Product Change Notification / ALAN-05LIKW552

CCB 6798 Initial Notice: Qualification of MMT as an additional assembly site for selected 23LC1024, 23A1024, 23LC512, 23A512, 23LCV1024, and 23LCV512 device families available in 8L TSSOP (4.4mm) package.

Pre and Post Change Summary

QUALIFICATION PLAN SUMMARY

ANAP

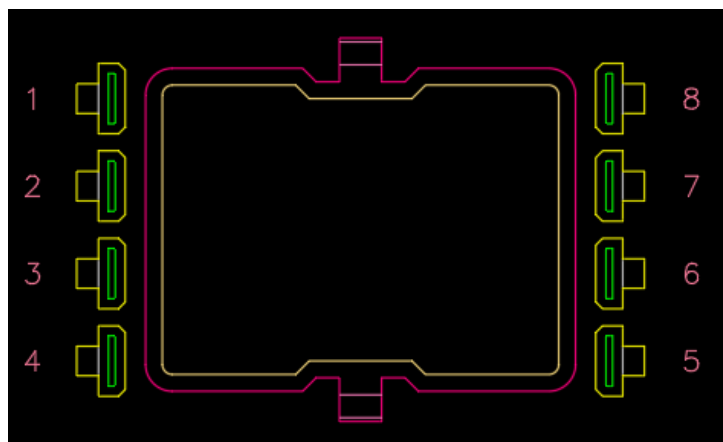
Lead-Frame Material	C7025
Lead-Frame Paddle Size	126 x 87 mils
DAP Surface Prep	Ag spot

NSEB

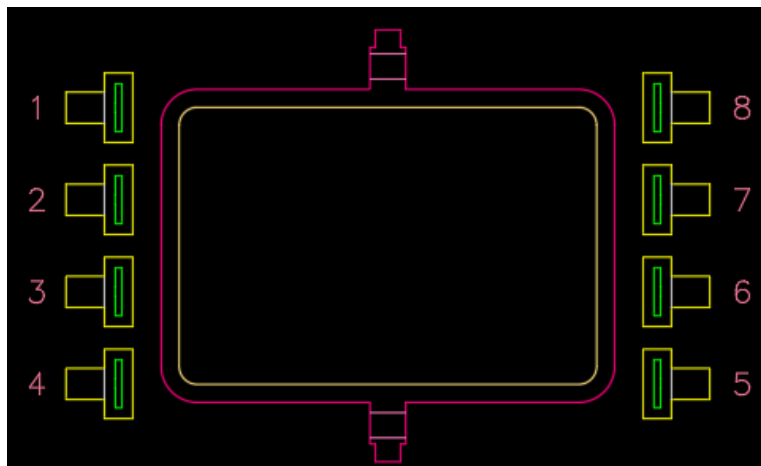
Lead-Frame Material	C7025
Lead-Frame Paddle Size	126 x 87 mils
DAP Surface Prep	Ag spot

MMT

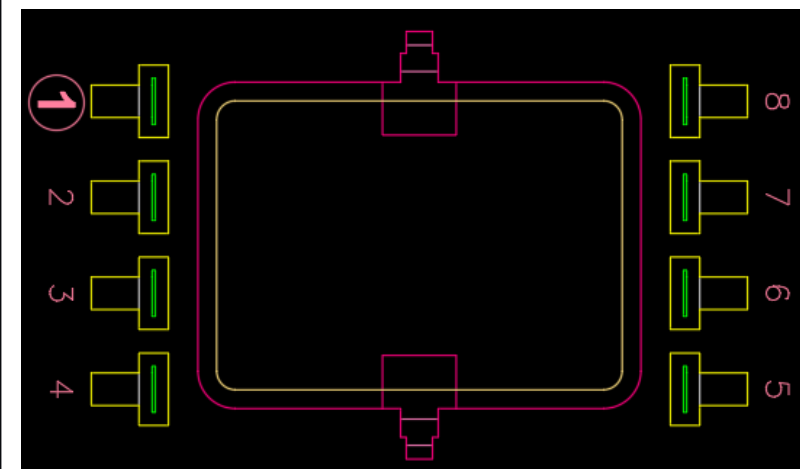
Lead-Frame Material	C7025
Lead-Frame Paddle Size	118 x 87 mils
DAP Surface Prep	Bare Cu
